AMENDMENT OF SOLICITATION/MODIFICATION OF CONTRACT				1. CONTRACT ID CODE		PAGE 1 OF 6 PAGES	
2. AMENDMENT/MODIFICATION NO. AMENDMENT NO. 0004		3. EFFECTIVE DATE 9/21/12		4. REQUISITION/PURCHASE REQ. NO.		5. PROJECT NO. (If applicable) 12-0066	
6. ISSUED BY CODE		mks		7. ADMINISTERED BY (If other than Item 6) CODE			
Officer in Charge of Construction MCI-East 1005 Michael Road Camp Lejeune, NC 28547-2521				See Item 6			
8. NAME AND ADDRESS OF CONTRACTOR (No., street, county, State and ZIP Code)				(X)		9A. AMENDMENT OF SOLICITATION NO. N40085-12-R-0066	
				X		9B. DATED (SEE ITEM 11) 9/7/12	
						10A. MODIFICATION OF CONTRACT/ORDER NO.	
						10B. DATED (SEE ITEM 11)	
CODE		FACILITY CODE

12-0066, Repair the MCAS New River Police Station, Bldg AS302

### CONTINUATION SHEET

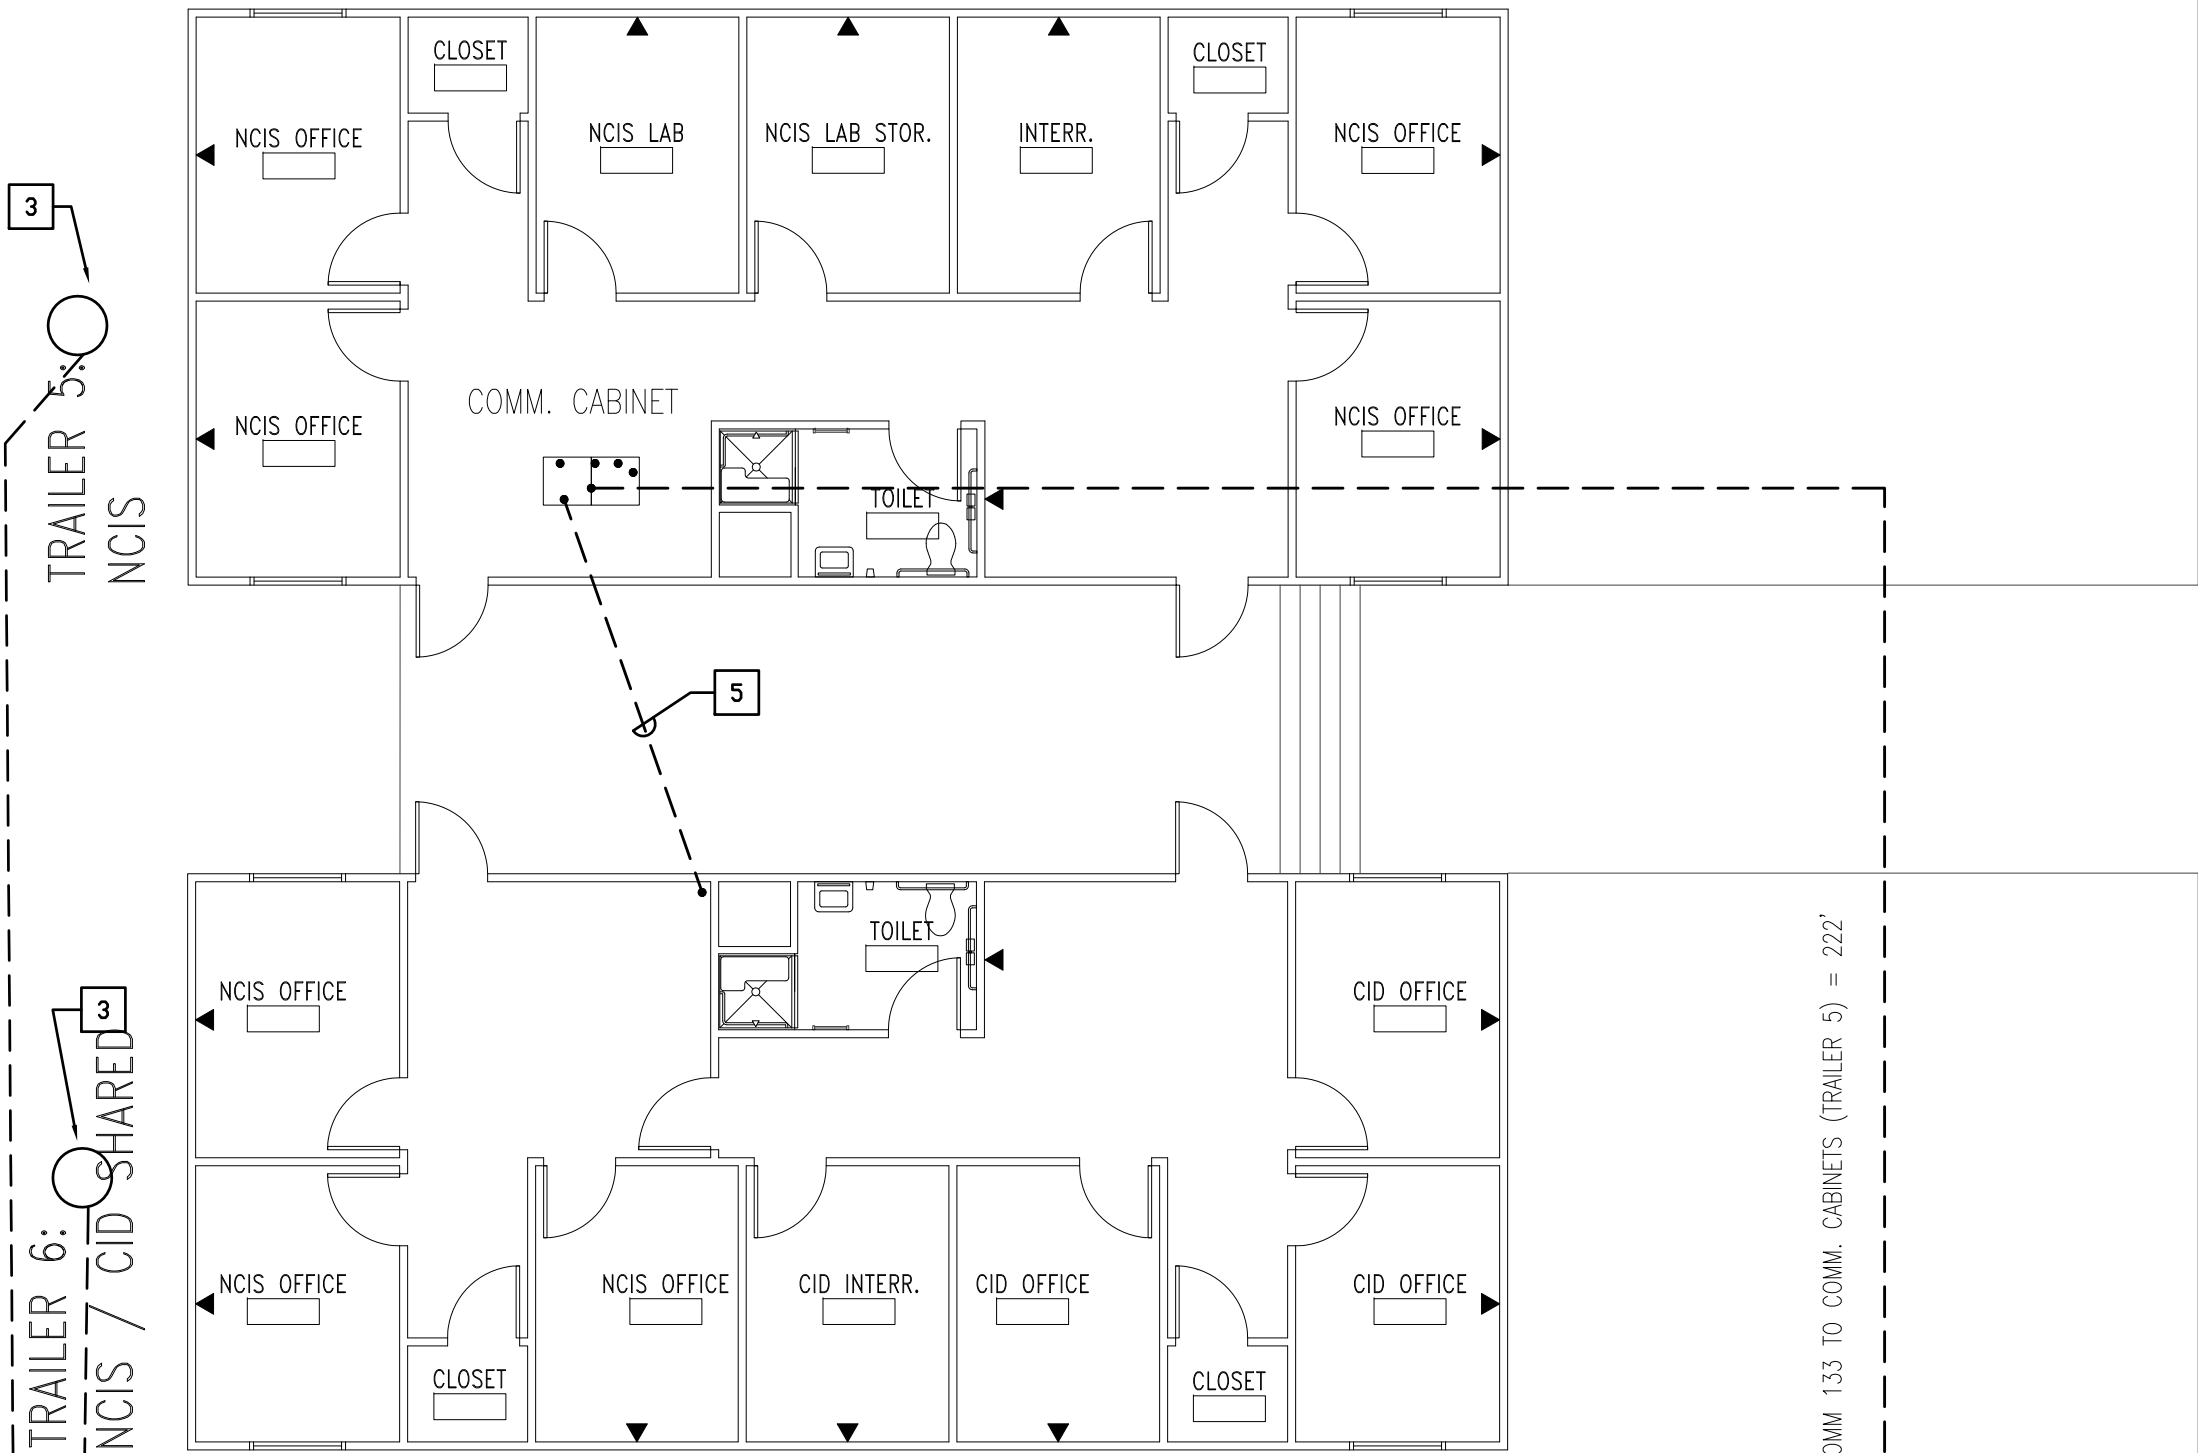
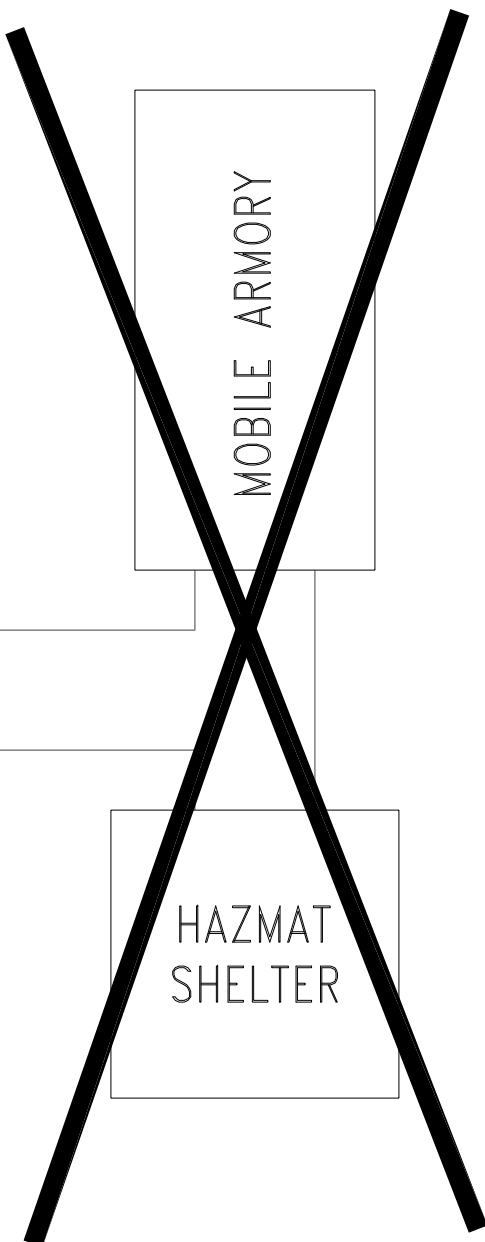
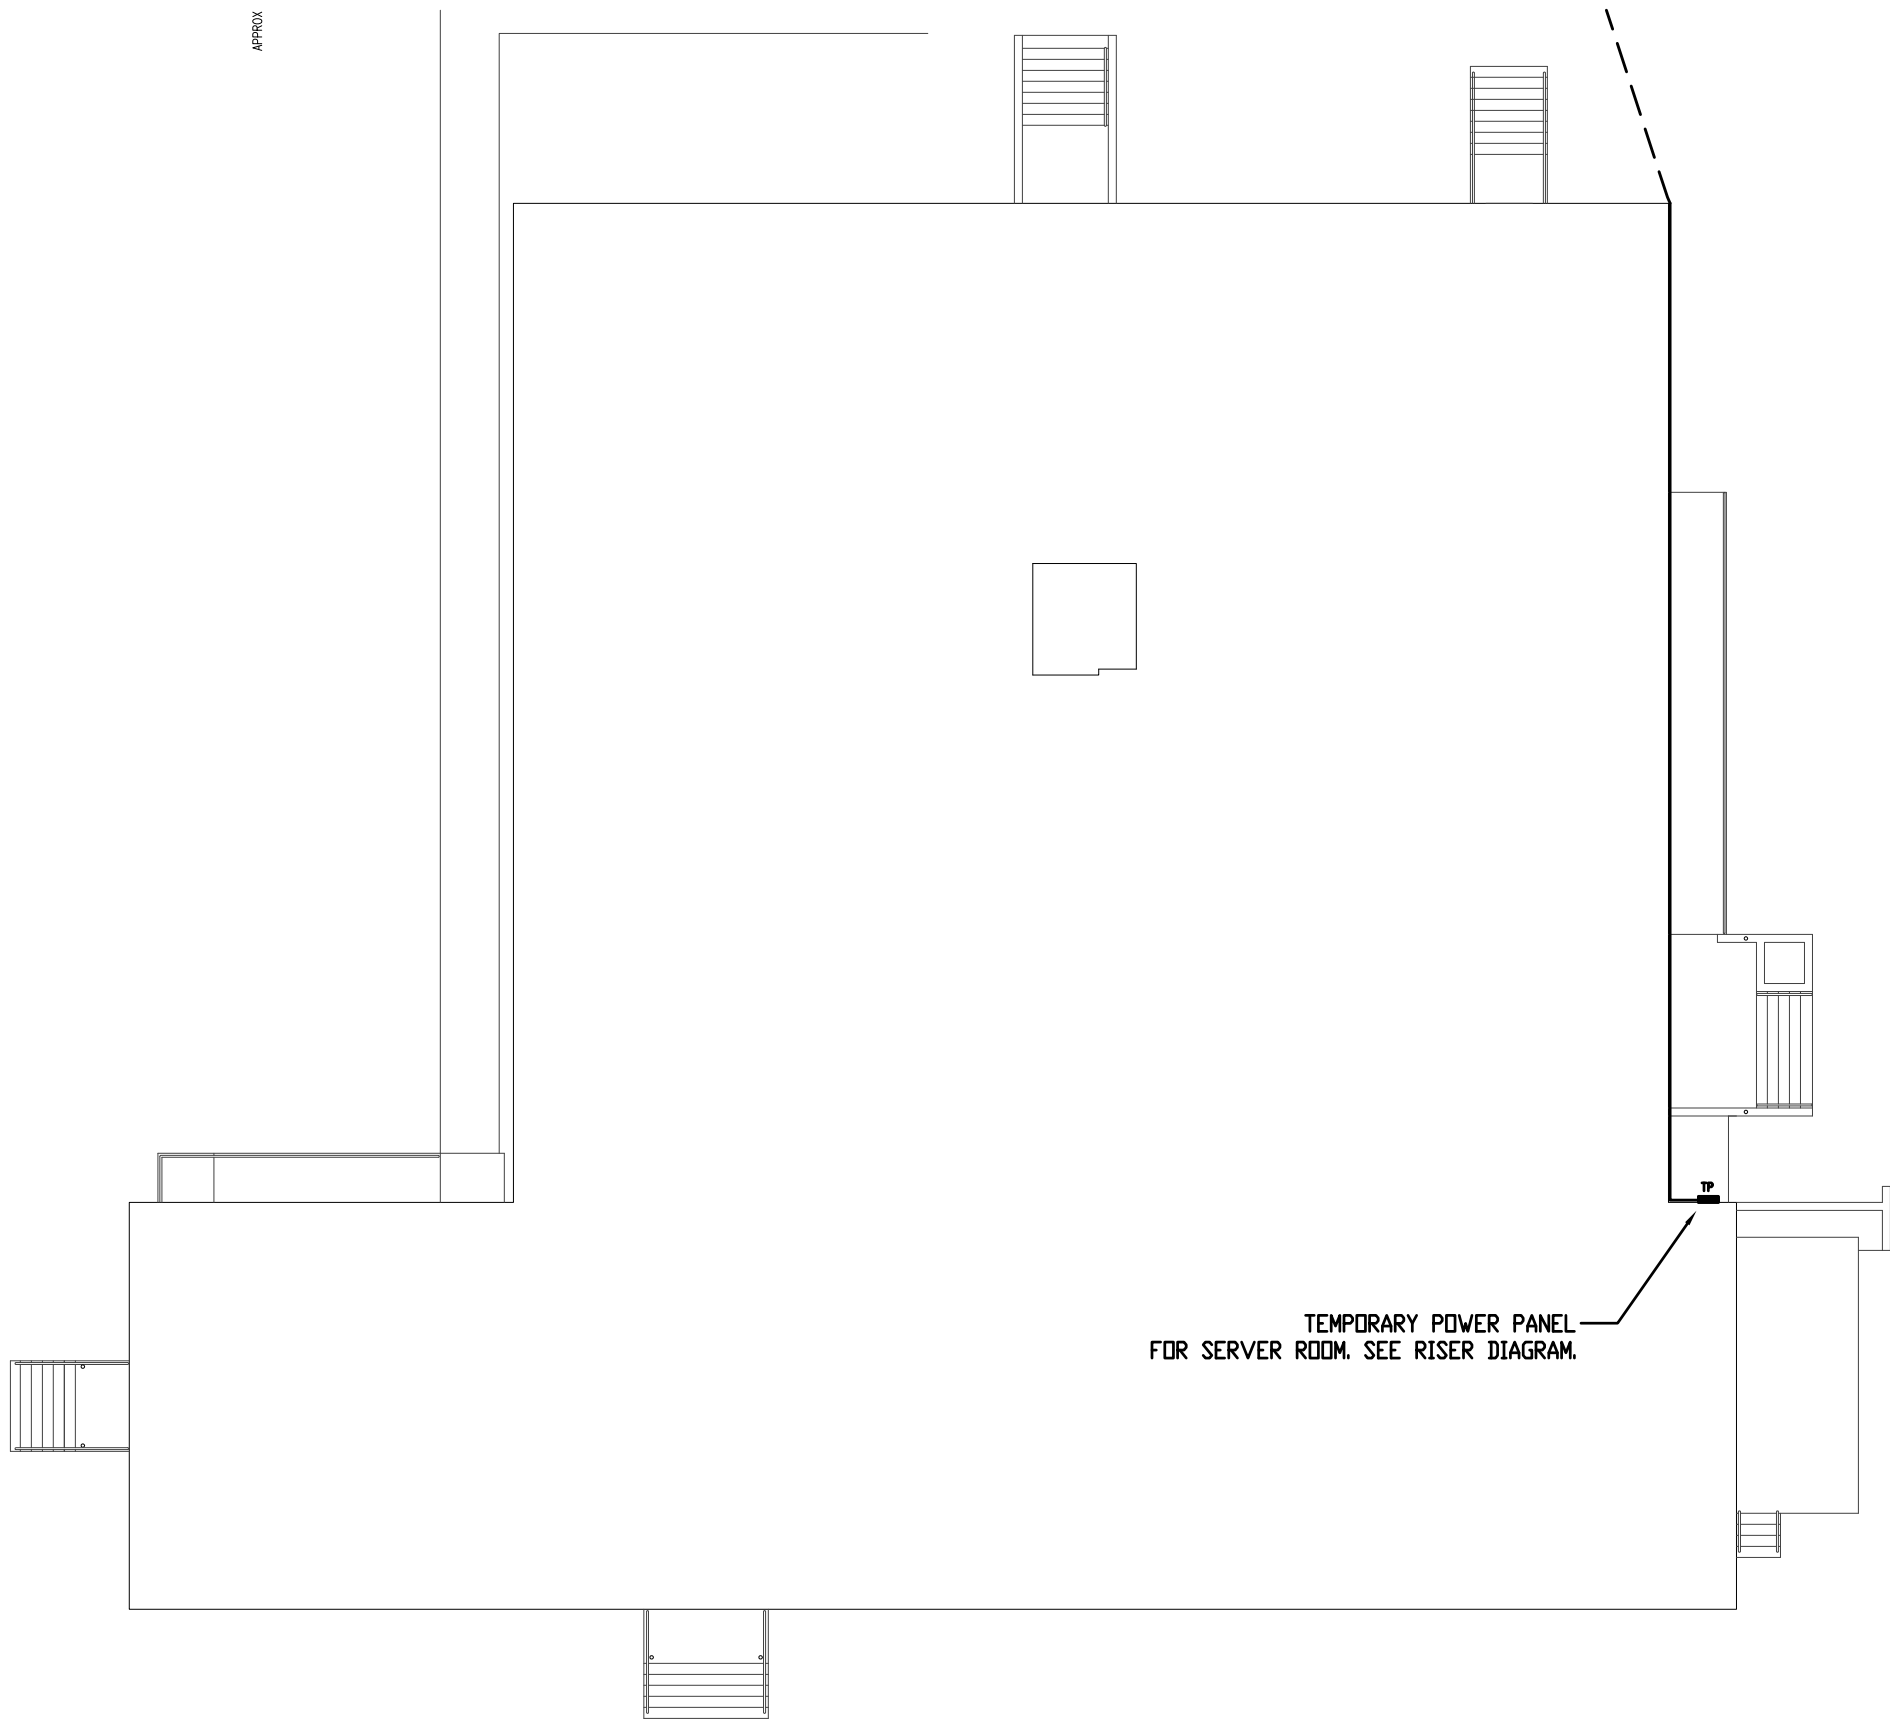
**1. Question:** With the reduced number of trailers as per amendment 3, what is the revised electrical layout for the new trailers, how is the temporary power affected. Please provide an updated electrical drawing reflecting the reduced trailer count.

**1. Answer:** See attached Revised Drawing E-103 which is hereby incorporated into the RFP (Request for Proposals) dated 7 September 2012.

TRAILERS 1 THROUGH 4 HAVE NOW BEEN ELIMINATED FROM THE SCOPE OF WORK. ALL ASSOCIATED POWER AND COMMUNICATIONS FEEDS FOR THESE TRAILERS HAVE BEEN DELETED.
